# HISTORIC AND DESIGN REVIEW COMMISSION

**HDRC CASE NO:** 2023-152  
**ADDRESS:** 320 MADISON ST  
**LEGAL DESCRIPTION:** NCB 744 BLK 3 LOT 16  
**ZONING:** RM-4, H  
**CITY COUNCIL DIST.:** 1  
**DISTRICT:** King William Historic District  
**APPLICANT:** MARGRET WILMOTH  
**OWNER:** MARGRET WILMOTH  
**TYPE OF WORK:** Construction of a 2-story rear accessory structure  
**APPLICATION RECEIVED:** April 14, 2023  
**60-DAY REVIEW:** Not applicable due to City Council Emergency Orders  
**CASE MANAGER:** Rachel Rettaliata

The applicant is requesting a Certificate of Appropriateness to construct a 2-story rear accessory structure.

A-1

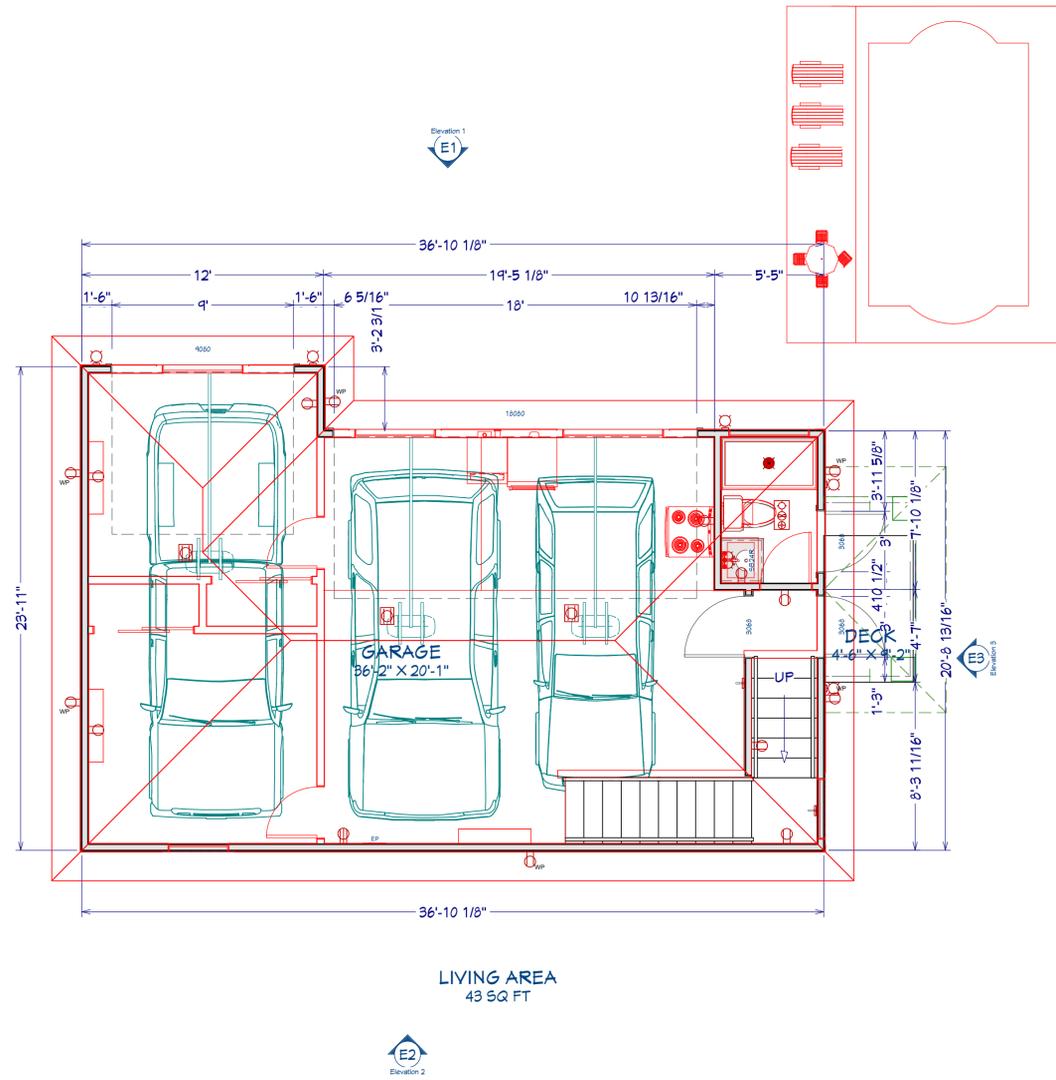
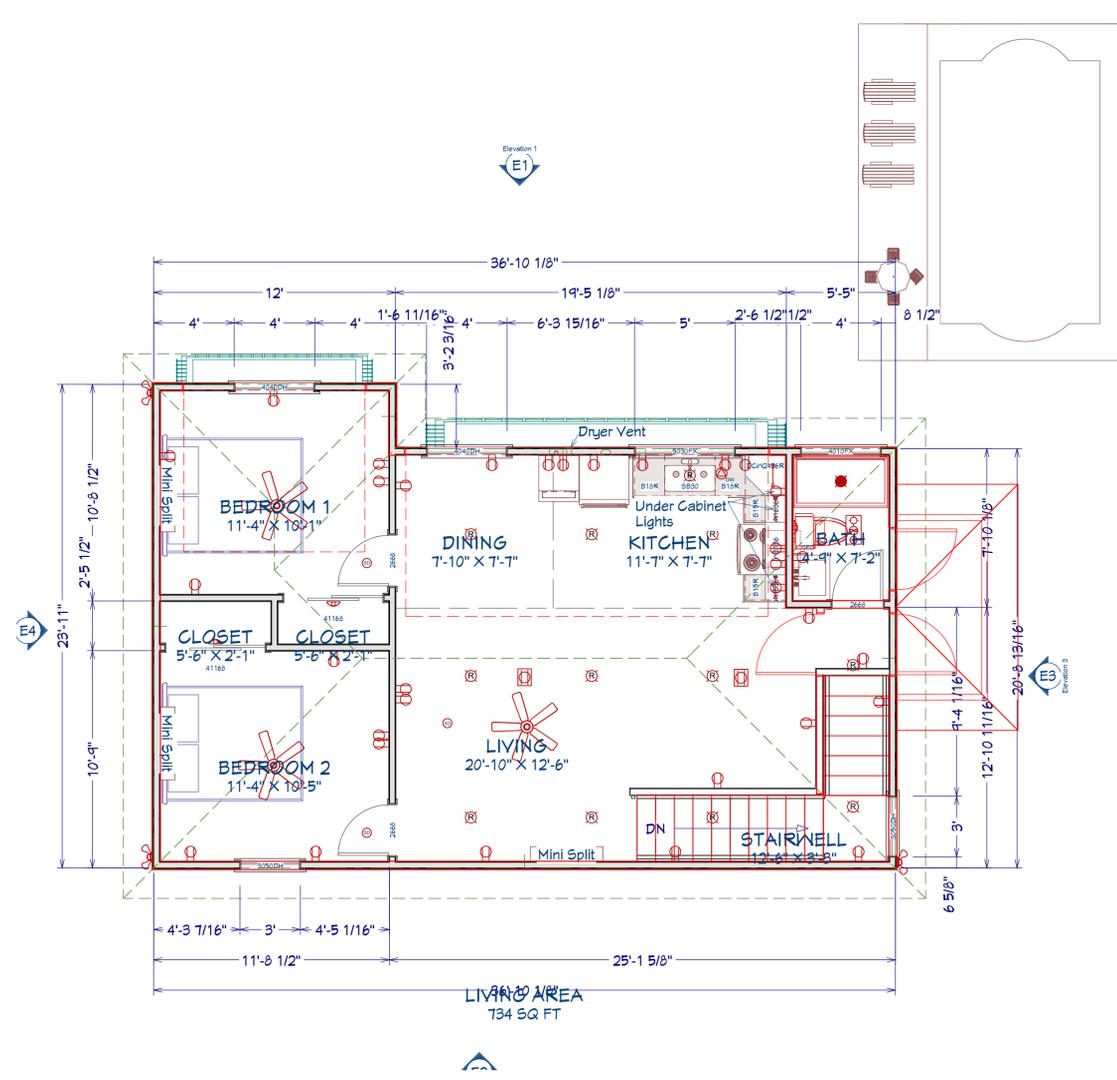
- c. NEW CONSTRUCTION: SETBACKS & ORIENTATION – The applicant has proposed to construct a 2-story rear accessory structure at the rear of the property. At this time, the applicant has not submitted a comprehensive site plan showing setbacks. According to the Guidelines for New Construction, the orientation of new construction should be consistent with the historic example found on the block. The applicant has proposed to orient the rear accessory structure on the lot to generally reflect that of the previous rear accessory structure on the site. Staff finds that the applicant should submit an comprehensive site plan to staff showing the proposed setbacks.

- e. NEW CONSTRUCTION: FOOTPRINT – The applicant has proposed a footprint of approximately 734 square feet. According to the Historic Design Guidelines, new construction should be consistent with adjacent historic buildings in terms of the building to lot ratio. The proposal is consistent with the historic development pattern of the district. Staff finds that the proposed footprint is appropriate for the property and the district.

- i. That the applicant submits a comprehensive site plan showing the proposed setbacks to staff for review and approval prior to the issuance of a Certificate of Appropriateness based on finding c.

Elevation 1

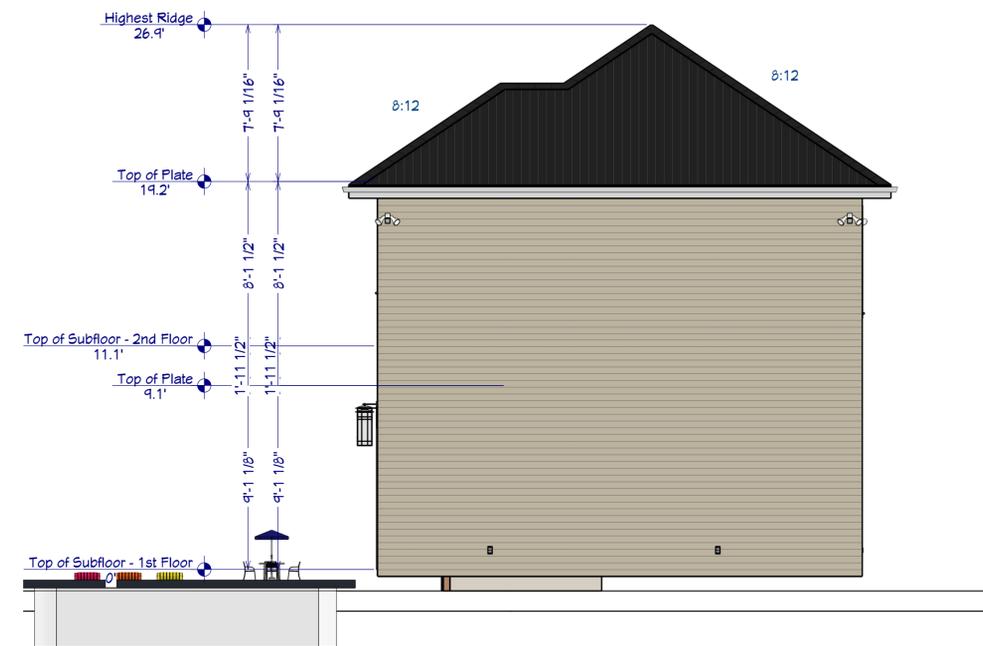
- g. NEW CONSTRUCTION: WINDOW OPENINGS – Per the Guidelines for New Construction 2.C.i., window and door openings with similar proportions of wall to window space as typical with nearby historic facades should be incorporated into new construction. The applicant has proposed to install one-over-one and fixed windows on the second floor of the structure in varying proportions. Staff finds that the applicant should propose a fenestration pattern that is more in keeping with the Guidelines.

- h. NEW CONSTRUCTION: DOOR OPENINGS – Guideline 5.A.v for New Construction states that applicants should incorporate garage doors with similar proportions and materials as those traditionally found in the district. The applicant has proposed to install 2 garage bays featuring one 2-car garage door and one 1-car garage door on the north elevation. The applicant has expressed that the existing pool, the turn radius into a third single-car garage bay would be limited. The applicant has proposed to install two (2) divided lite pedestrian doors on the north elevation to access the first floor and to access the stairs to the second story. The applicant has not submitted material specifications at this time. Staff finds that the applicant should modify the fenestration pattern to feature 3 garage bays, featuring three 1-car garage doors to match those found on historic garages in the district. Fully wood doors would be most appropriate.

- j. NEW CONSTRUCTION: ARCHITECTURAL DETAILS – New buildings should be designed to reflect their time while representing the historic context of the district. Additionally, architectural details should be complementary in nature and should not detract from nearby historic structures. The applicant has proposed to construct a side porch on the north elevation with a pyramidal roof and square columns. Additionally, the applicant has proposed to install two (2) Juliet balconies on the front elevation of the rear accessory structure to match the railings on the primary structure. The applicant has expressed that the design of the railing in the rendering is not the design that is currently proposed. Staff finds that a Juliet balcony at window openings to be inappropriate and not in keeping with the historic context of the district. Staff finds that the applicant should submit updated drawings showing side porch column details and should propose architectural details in keeping with the Historic Design Guidelines.

- ii. That the applicant proposes window sizes, patterns, proportions, and trim and sill detailing that are consistent with the Guidelines and historic precedents in the district as noted in finding g and submits updated elevation drawings to staff for review and approval prior to the issuance of a Certificate of Appropriateness.

- iv. That the applicant installs single-car garage doors in lieu of the proposed 2-car garage door based on finding h. Updated elevation drawings must be submitted to staff for review and approval prior to the issuance of a Certificate of Appropriateness.

- vii. That the applicant submits updated elevation drawings that propose architectural details that are in keeping with the Historic Design Guidelines and do not feature Juliet balconies based on finding j.
